**TOP VIEW OF WING ARMORING WITH WING EXTENSION**

09-14 LATEST REVISION DATE  <i>Thomas E. M. Donnell</i> APPROVED BY BRIDGE ENGINEER		
	STANDARD DESIGN - 44' ROADWAY, THREE SPAN BRIDGE <b>PRETENSIONED PRESTRESSED CONCRETE BEAM BRIDGES</b> MARCH, 2007	
	<b>WING ARMORING DETAILS</b> C BEAMS	<b>H44-76-07</b>

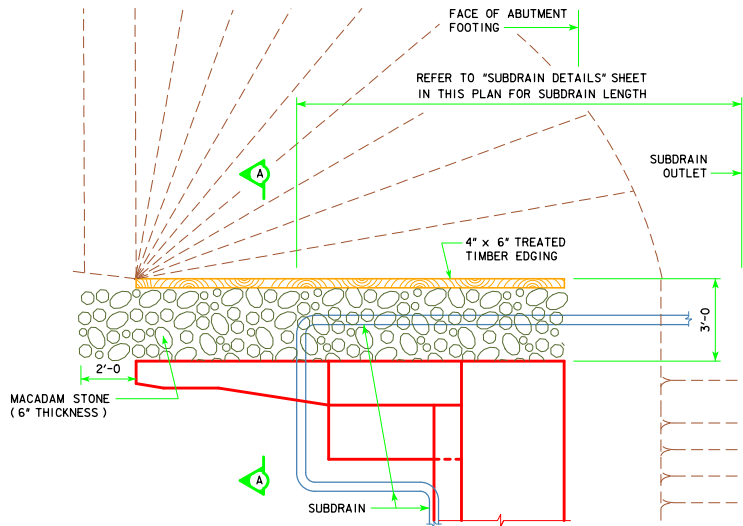
REVISED 09-14 - CHANGED THE AREA OF THE MACADAM STONE AREA TO 2'-0" IN FRONT OF THE BRIDGE WING.
